00960
CITY OF PORTLAND

Location 2 Dedham Street
Owner's name and address Nellie F. Thorne, 2 Dedham St. Telephone _____
Contractor's name and address owner Telephone _____
Use of building—Present 1 car garage Proposed _____
No. of Stories 1 Style of roof pitch Type of present roof covering asphalt
Type and Grade of roofing to be used asphalt Class C. Urd. Lab. No. plies _____

This is in reference to your application for an amendment to your building permit 90/0386 for the construction of an exterior stairway in the R-7 Residence Zone.

Proposed Central Support

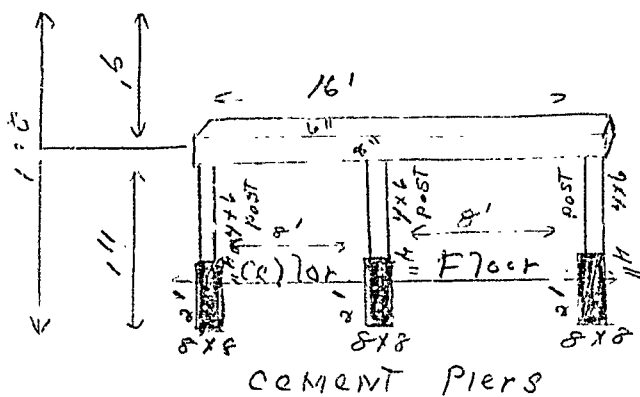
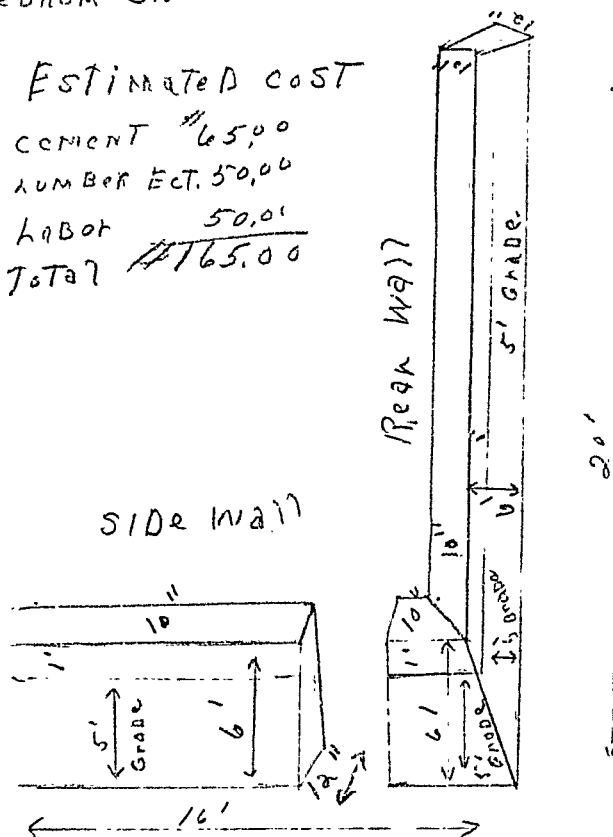
To construct concrete foundation wall on 1 side and rear of building
12" thick at bottom, 10" at top at least 4' below grade of ground, fill at least
6" above grade
To strengthen floor as per plan.

Addition of exterior stairway.
PLOT PLAN.

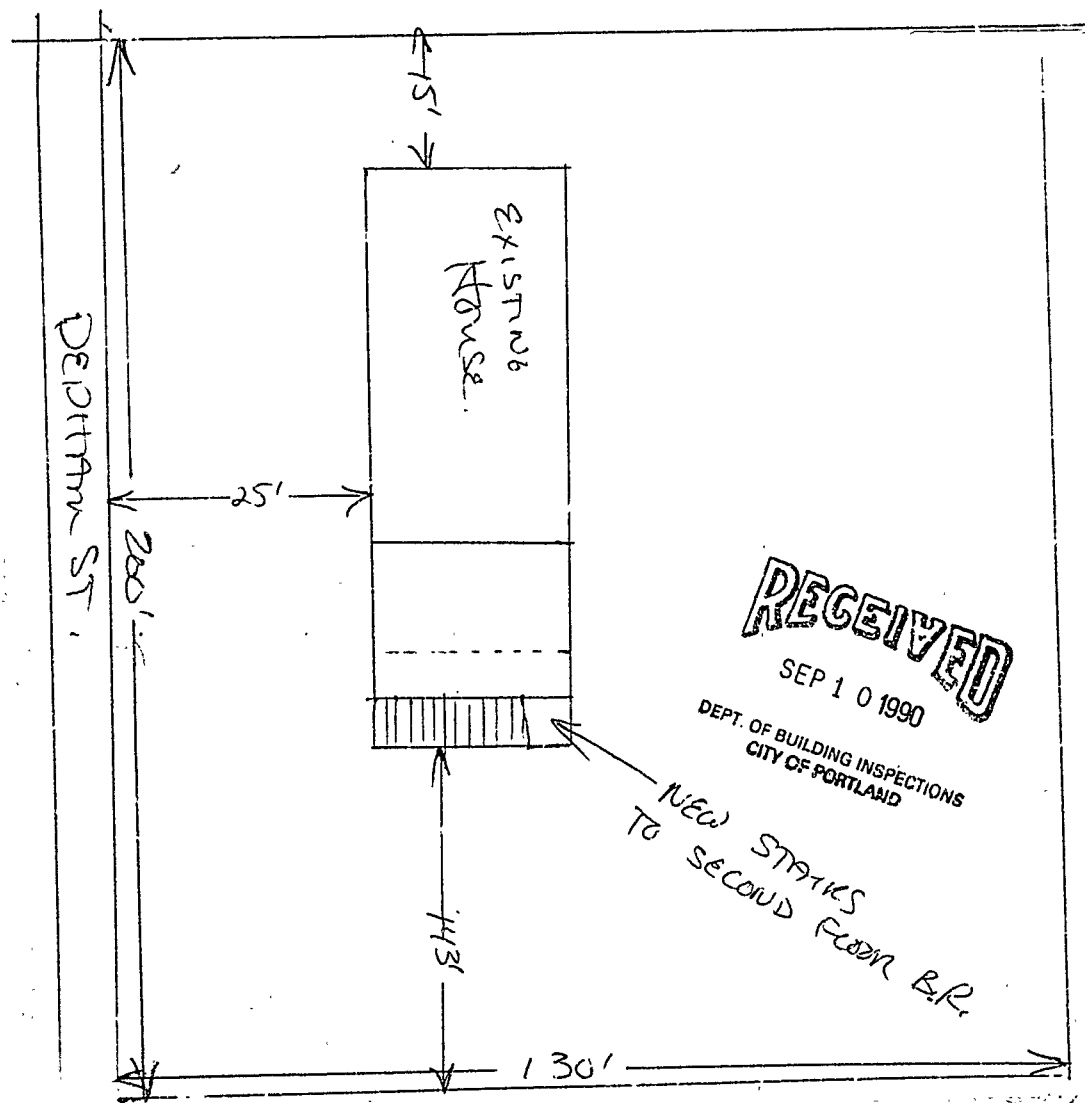
In order to continue processing of this amendment, we shall require a plot plan showing how the setbacks for front side and rear are affected by the proposed outside stairway. Please furnish a plot plan which will indicate the dimensions for these setbacks once the proposed stairway is constructed.
